August 8, 2022

Planning Board

RE: 213 Vineyard Meadows Farm Road Site Plan Review

DIAGRAM #1 (EXISTING LANDSCAPE AND ABUTTERS)

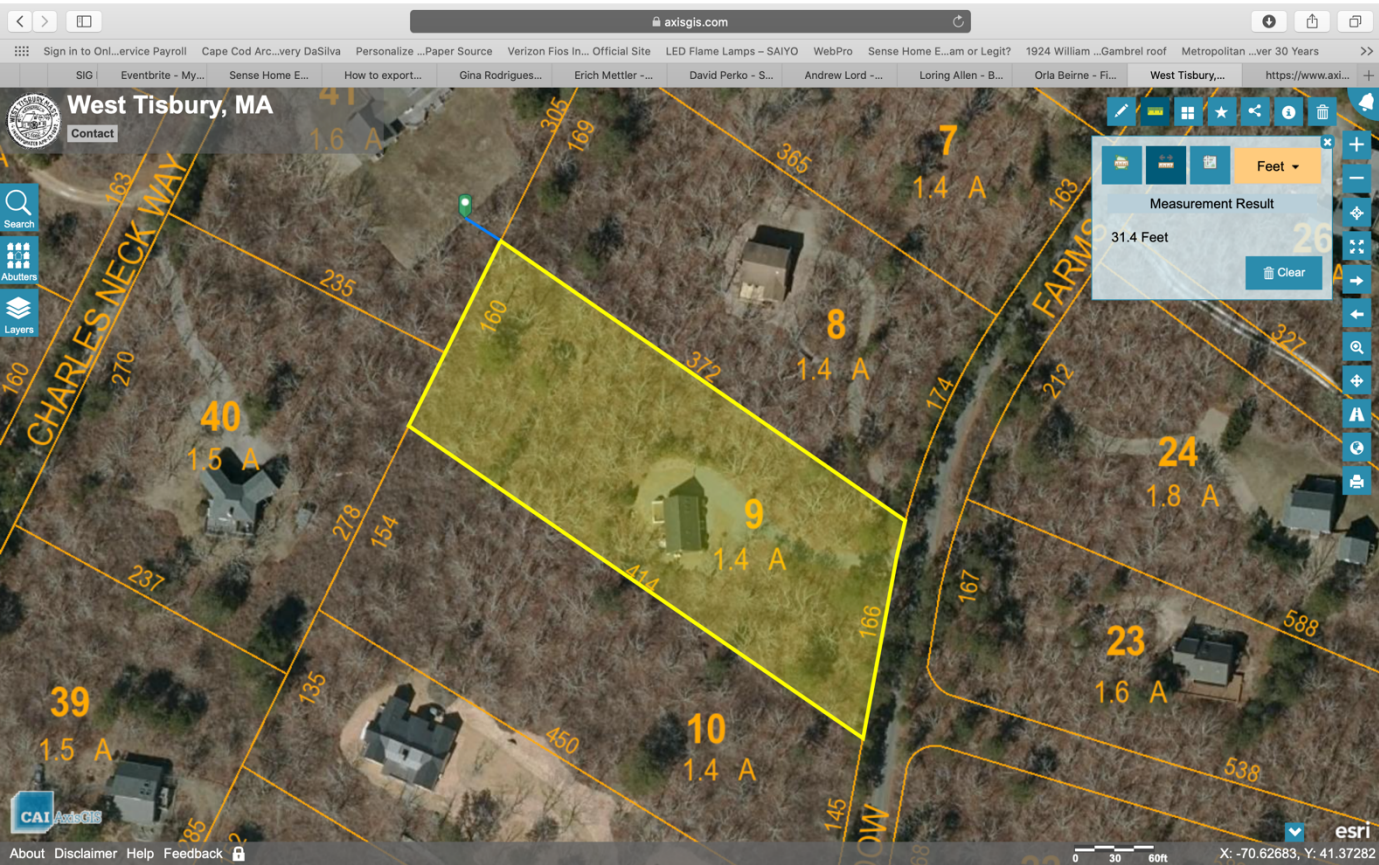
3. A Site Plan with proposed building footprint with dimensions.
4. A Site plan noting existing vegetation and other natural features (e.g. major trees, rock outcroppings, streams, wetlands, etc.). As Mr. Silva stated during the September 8, 2022 West Tisbury Board of Health meeting, eliminating trees and vegetation can significantly reduce nature's ability to reduce nitrogen from ground water which is created from septic system waste water. This means that a septic system drainage structure should be located on the lot where

it will require the least removal of the existing landscape buffer and allow for new buffer to be planted. Mr. Silva's firm provides engineering and survey services to Squash Meadow Construction Inc. and the property owners of 213 Vineyard Meadow Farms Road.

5. A Site Plan with proposed tree clearing and civil disturbances.
6. A Site plan reflecting "Buffer Landscape" and privacy structures (i.e. fences). Landscaping should serve to create a buffer between houses and the streets for privacy and to retain the natural "woody" character of West Tisbury. The larger the house, the greater the buffer that will be required. To best achieve this, the existing native trees, understory and bushes should be preserved as much as possible. The Property owner informed us they intend to add vegetation and other privacy structures but none of this is reflected in the Site Plan submitted to the Planning Board and public.

DIAGRAM #2 (BASEMENT WINDOW WELLS DESIGNED FOR NATURAL LIGHT AND EGRESS)

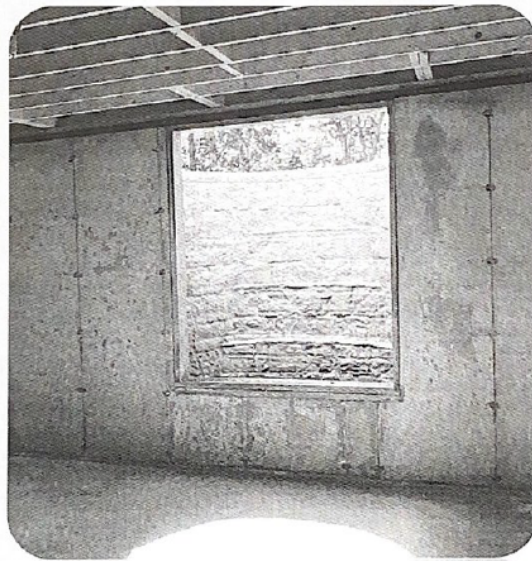
- On the right gable we will have a Bilco Type C Bulkhead which will encroach on the setback by approx. 4' and 2 Redi-Exit Window Wells which will be no more than a 1' encroachment on the setbacks and covered with metal grates.
- On the left gable we would like to build a rinsing area and landing that will encroach approximately 4' into the setback.

I have attached a picture of the window wells in case anyone is unfamiliar with the product. It allows a window to become a form of egress in care of any emergency.
